SANTA BARBARA COUNTY PLANNING COMMISSION
Staff Report for Appeals of CBAR and P&D Denials of
Bean Blossom Lot X New Residence, Guest House and Accessory Structures

Hearing Date: November 5, 2008
Staff Report Date: October 17, 2008
Case Nos.: 08APL-00000-00031 (03BAR-00000-00164) and
08APL-00000-00032 (02CDP-00000-00023)
Environmental Document: CEQA Exempt § 15270

ATTACHMENT E: SITE PLAN

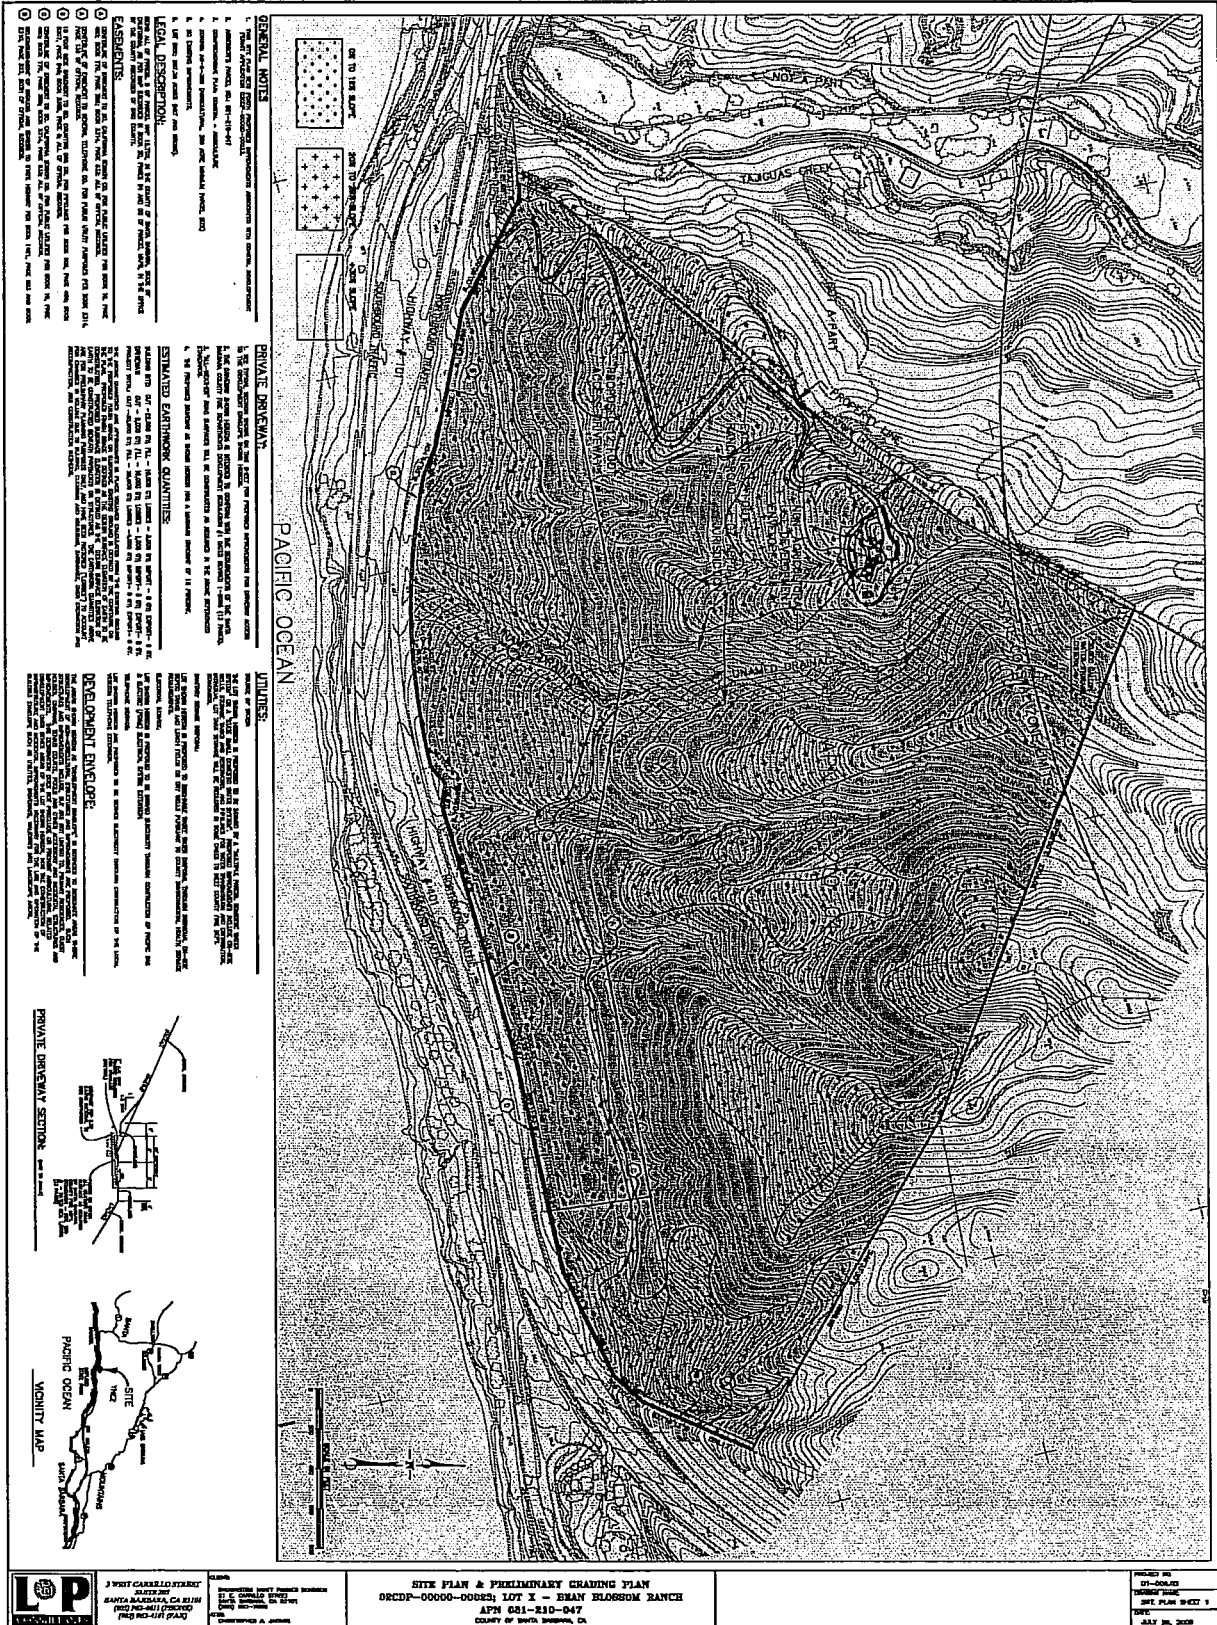
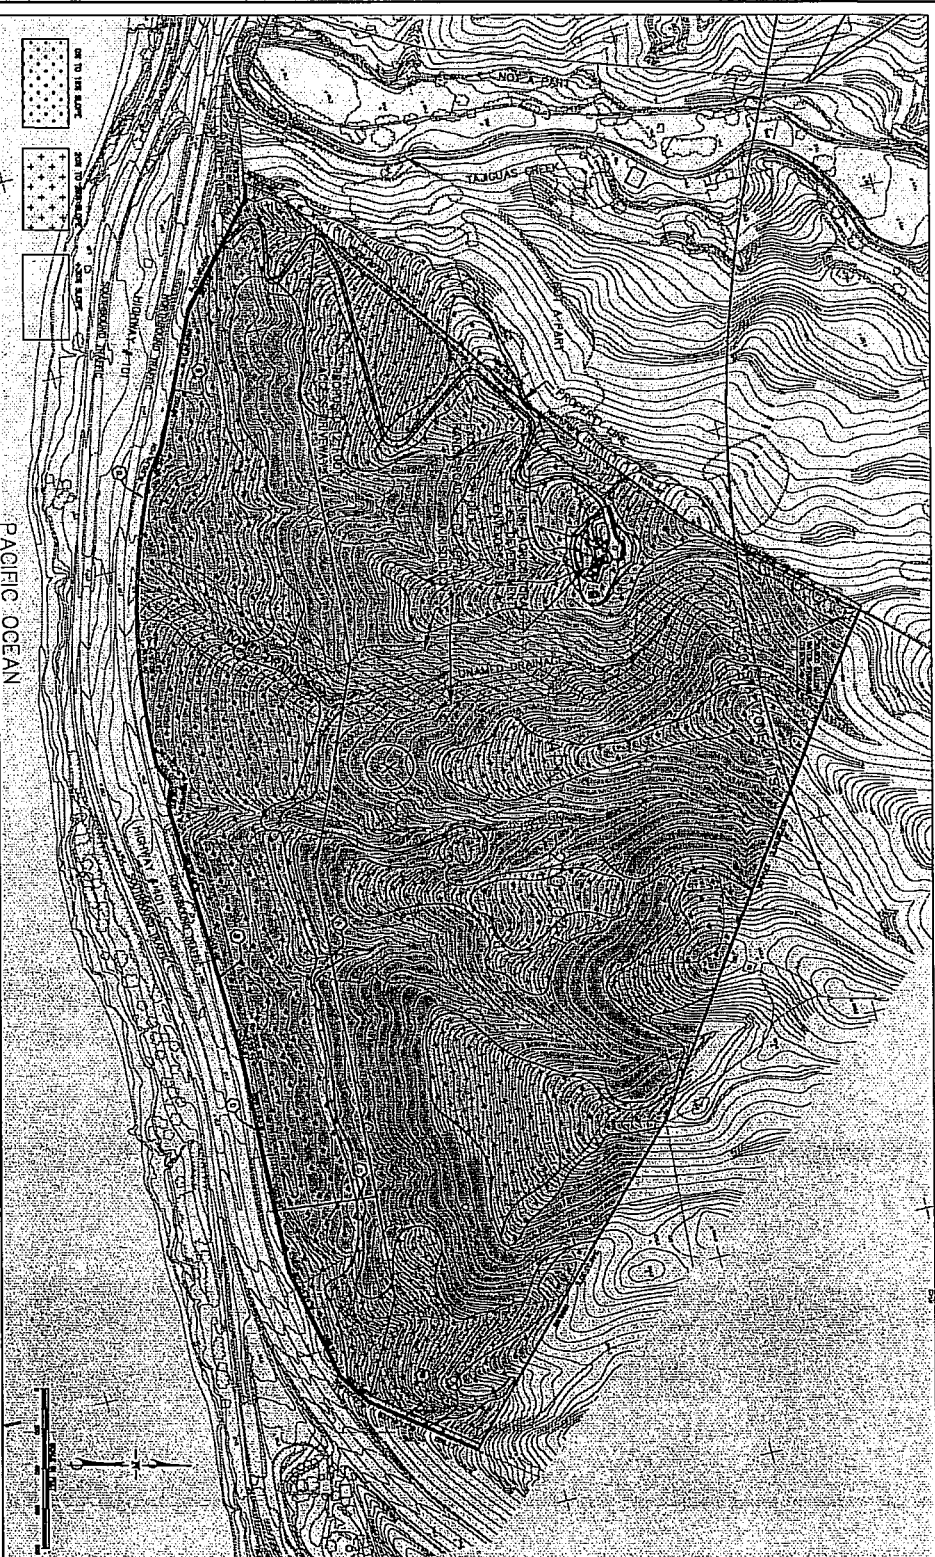
The proposed residence and adjoining structures and features were designed for a level building site. The proposed 2-acre development area has moderate slopes. (See site plan in Attachment E of this staff report.) Contrary to the policies cited in Section 6.2 above, the applicant is proposing to alter the natural topography to fit the project rather than proposing a project designed to fit the natural topography. This results in excessive grading and alteration of the natural terrain.

P&D's Response: The project includes a significant amount of development spread out over a relatively large area with moderate slopes. The combination of a large residence and motor court, dispersed accessory structures and extensive yard and landscaping results in a large development area and, consequently, excessive cutting and filling. The residence and guest house total approximately 18,944 square feet (gross area). The residence is approximately 220 feet in length. The motor court is approximately 70 feet in diameter and requires more than 6,000 square feet. The motor court and associated retaining walls extend almost 100 feet north of the residence. The pool and guest house are located approximately 60 feet south and east, respectively, of the residence. Substantial yard and landscaping are proposed in and around these accessory structures.

The proposed development area encompasses 1.98 acres. The proposed grading would extend beyond the boundary of the development area. Siting development north (upslope) of the residence requires significant cutting of the existing hillside. For example, the vertical distance between natural grade and finished grade is up to approximately 22 feet within the footprint of the motor court. Siting development south (down slope) of the residence requires significant filling of the existing slopes. For instance, the pool and yard south of the residence require up to approximately 10 feet of fill on top of the natural grade. Staff concluded that a smaller and more compact project with a smaller yard and less landscaping would be more consistent with the applicable policies. These changes would significantly reduce cut and fill operations, minimize alteration of the natural terrain and result in a project that is compatible with the character of the surrounding natural environment.
